PERMIT # 001225 CITY OF Portland BUILDING PERMIT APPLICATION MAP # \_\_\_\_\_ LOT# \_\_\_\_\_

LOCATION OF CONSTRUCTION: 08-B-6 Vermont Ave., Peaks Island

October 4, 1988

BUILDING PERMIT REPORT

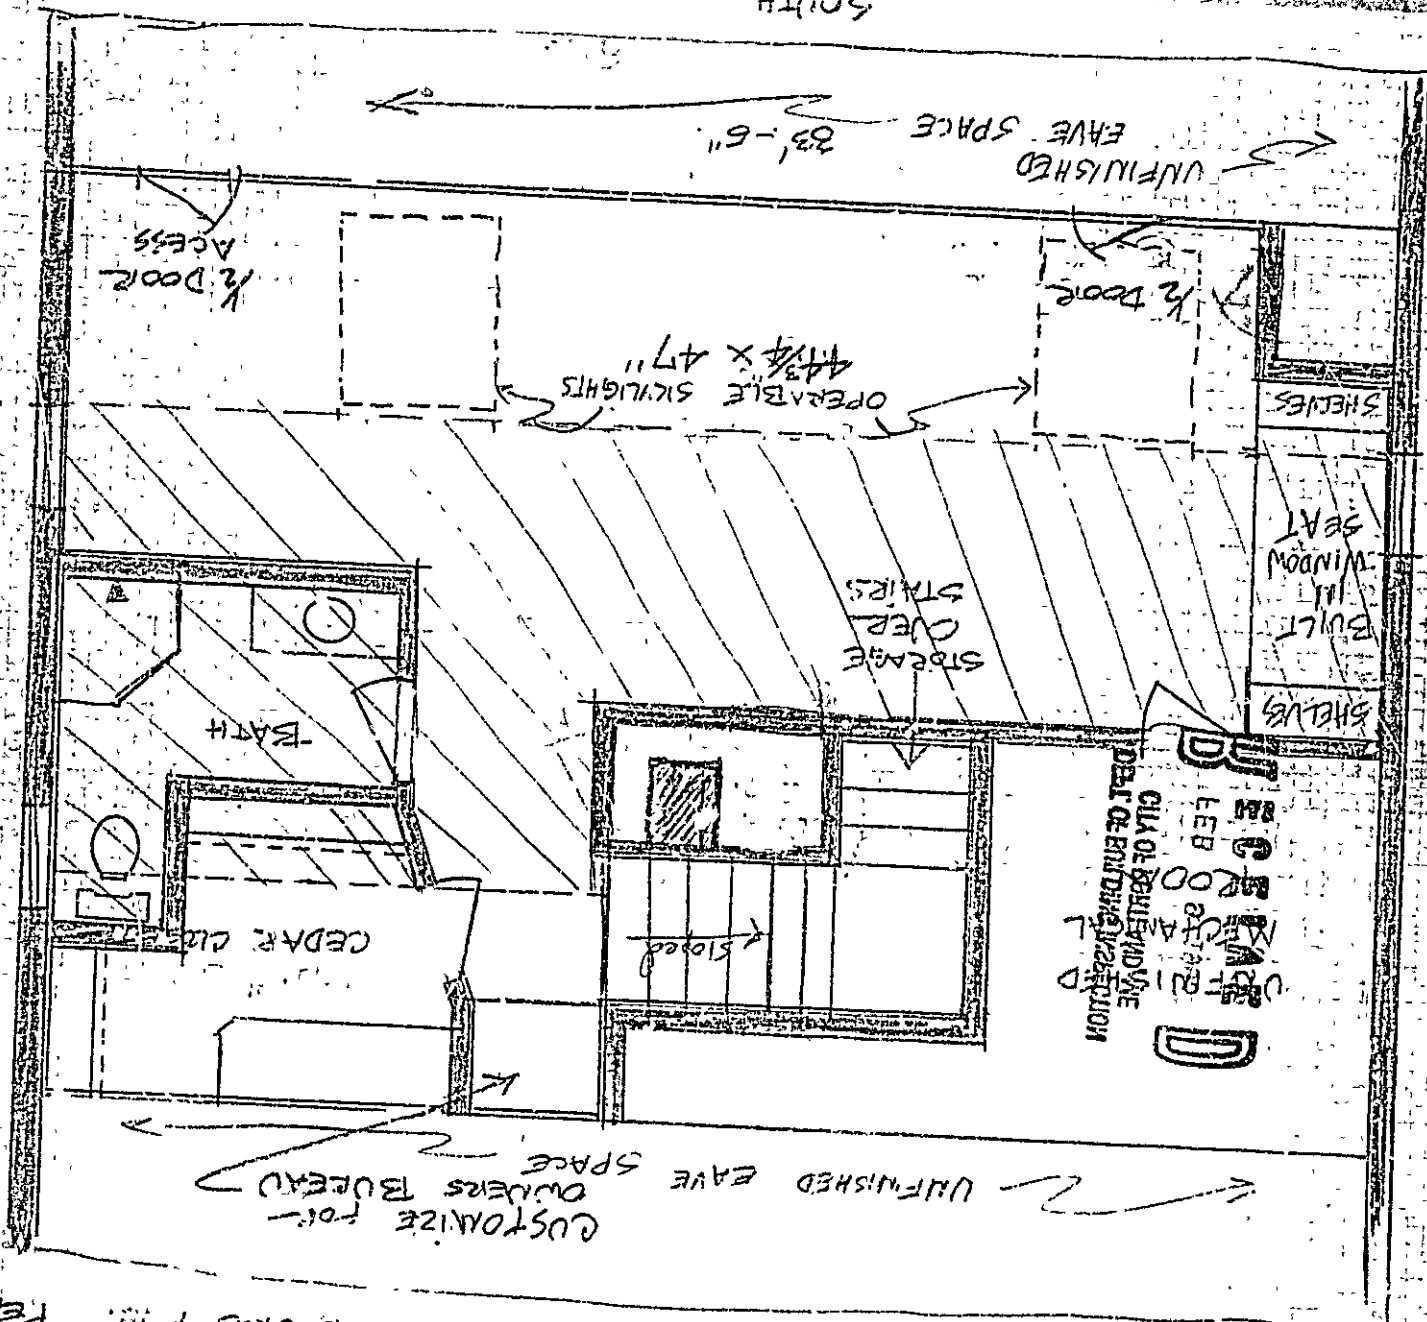
1. Please read and implement items 4 & 5 and 7 of the attached building permit report.
2. Before placing foundation all setback must be approved by inspection services and elevations by Public Works.
3. The rafter shown on your plans are 2" x 6". A minimum of 2" x 8" at 16" o.c. must be used in th's spec.
